CW Tip 6 — Drawbar and Chuck Adapter Through-Drill Modification/Roger Adams

Modifying the Drawbar and Chuck Adapter

FIGURE 1—The blue box indicates the new drill-through hole for the Sherline Rotary Table-to-Chuck Adapter.

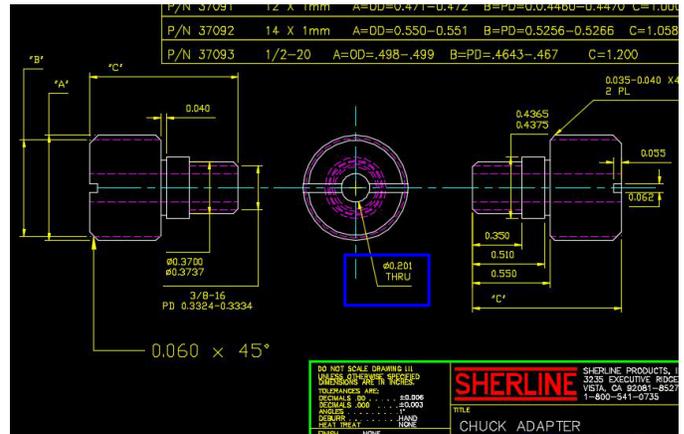
I am using these to make a clock (I'm a clock and watch repairer), and eventually will use them to make a watch from scratch. To this end, I purchased the #3060 milling collets, which I use on both the lathe and the mill for holding and machining drill rod for making clock arbors, etc. If I may make a suggestion regarding these, it would be a good idea if you would supply the associated drawbolt through-drilled to allow a long piece of 3/16", or smaller, stock to be used with them. I actually modified the drawbolt myself like this and it proved most effective. I also through-drilled the #37090 chuck adapter for the rotary table for the same reason. FYI, I needed to mill flats on the end of a long piece of 3/16" drill rod, using the rotary table on the mill to do this and without through-drilling the adapter first as I did, the rod would have stuck out too far from the chuck mounted on the rotary table to allow for this.

With the feedback from Roger Adams, we have decided to add a .020" through-hole to our P/N 37090 Rotary Table-to-Chuck Adapter. This modification will take place on the next part run.
